APPLICANT: OWF Investment Corp.	PETITION NO:	Z-69
PHONE#: (770) 354-1080 EMAIL: owf@att.net	HEARING DATE (PC):	10-07-14
REPRESENTATIVE: Omer W. Franklin, III	HEARING DATE (BOC): _	10-21-14
PHONE#: (770) 354-1080 EMAIL: owf@att.net	PRESENT ZONING:	R-20
TITLEHOLDER: Harry E. Anderson, Brenda J. Southern, Mark F.		
Haman and Lisa J. Haman	PROPOSED ZONING:	R-15
PROPERTY LOCATION: West side of Sewell Mill Road, south of		
Braswell Road	PROPOSED USE: Resider	ntial Subdivision
(2269 Sewell Mill Road, 991 and 1021 Braswell Road).		
ACCESS TO PROPERTY: Sewell Mill Road	SIZE OF TRACT:	4.58 acres
	DISTRICT:	16
PHYSICAL CHARACTERISTICS TO SITE: Single-family houses	LAND LOT(S):	987, 988
on one-acre+ lots	PARCEL(S):	5, 2, 3
	TAXES: PAID X DU	J E
CONTIGUOUS ZONING/DEVELOPMENT	COMMISSION DISTRICT	: _ 3

APPLICANT: OWF Investment Corp.	PETITION NO	J.:
PRESENT ZONING: R-20	PETITION FO	PR: R-15
*********	*******	* * * * * * * * * * *
ZONING COMMENTS: Staff Membe	r Responsible: Jason A. Campbe	<u></u>
Land Use Plan Recommendation: Low Dens	ity Residential (1-2.5 units per acre))
Proposed Number of Units: 9	Overall Density: 1.97	Units/Acre
Staff estimate for allowable # of units: 8 *Estimate could be

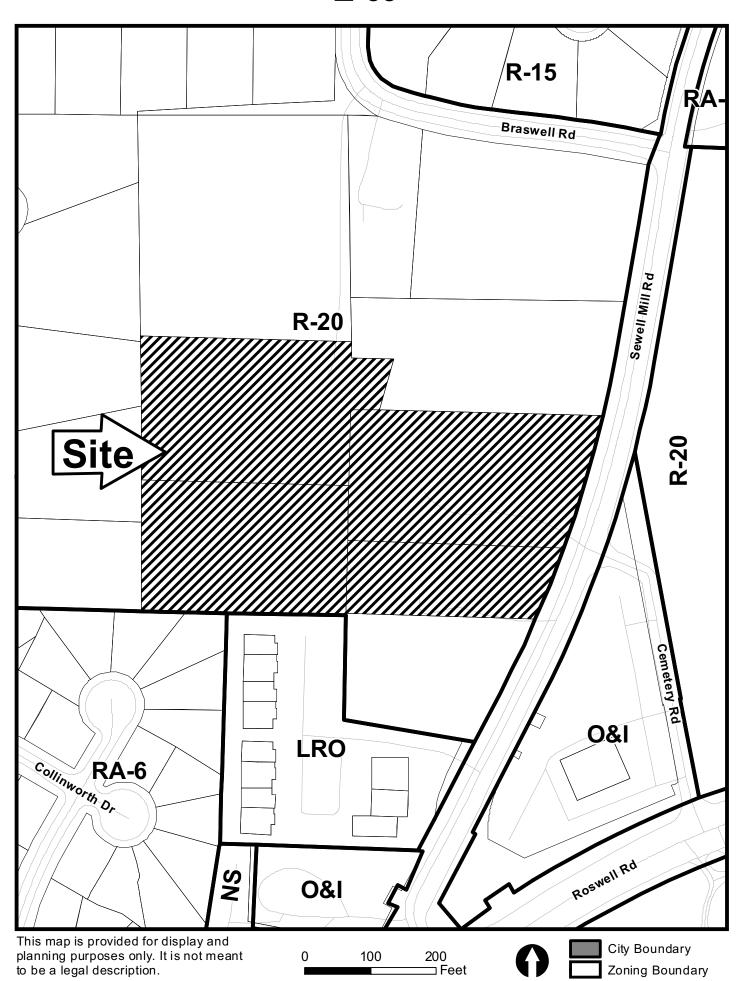
APPLICANI: OWF Investment Corp.	PE IIIION NO.: <u>Z-69</u>
PRESENT ZONING: <u>R-20</u>	PETITION FOR: <u>R-15</u>
***********	**********
STORMWATER MANAGEMENT COMMENT	S – Continued
SPECIAL SITE CONDITIONS	
 □ Provide comprehensive hydrology/stormwater controls □ Submit all proposed site improvements to Plan Review. □ Any spring activity uncovered must be addressed by a □ Structural fill must be placed under the direction engineer (PE). □ Existing facility. □ Project must comply with the Water Quality require County Water Quality Ordinance. □ Water Quality/Quantity contributions of the existing laconditions into proposed project. □ Calculate and provide % impervious of project site. 	qualified geotechnical engineer (PE). n of a qualified registered Georgia geotechnical ements of the CWA-NPDES-NPS Permit and
Revisit design; reduce pavement area to reduce runoff a INSUFFICIENT INFORMATION	nd pollution.

No Stormwater controls shown Copy of survey is not current − Additional comments nare exposed. No site improvements showing on exhibit. 	nay be forthcoming when current site conditions

- 1. The parcel is located just east of Sewell Mill Road. The majority of the site drains to the west across an adjacent residential lot to an unnamed tributary to Sope Creek. The remainder (1/5) drains to the southeast to the Sewell Mill Road R/W. The site is a mixture of open agricultural and woodland. The average slope on the site is approximately 10%.

- 2. There is not a well-defined existing conveyance for the proposed detention pond. An offsite drainage easement will be required to convey the concentrated pond discharge to the adjacent receiving stream to the east or the outlet must be designed to restore sheet flow conditions at the adjoining property line.

- 3. There is an existing private lake located to the southeast of Roswell Road that is within 1500 feet of the site. This lake has had previous sediment impacts from upstream development and GDOT road improvements. A pre- and post-development sediment survey will be required.
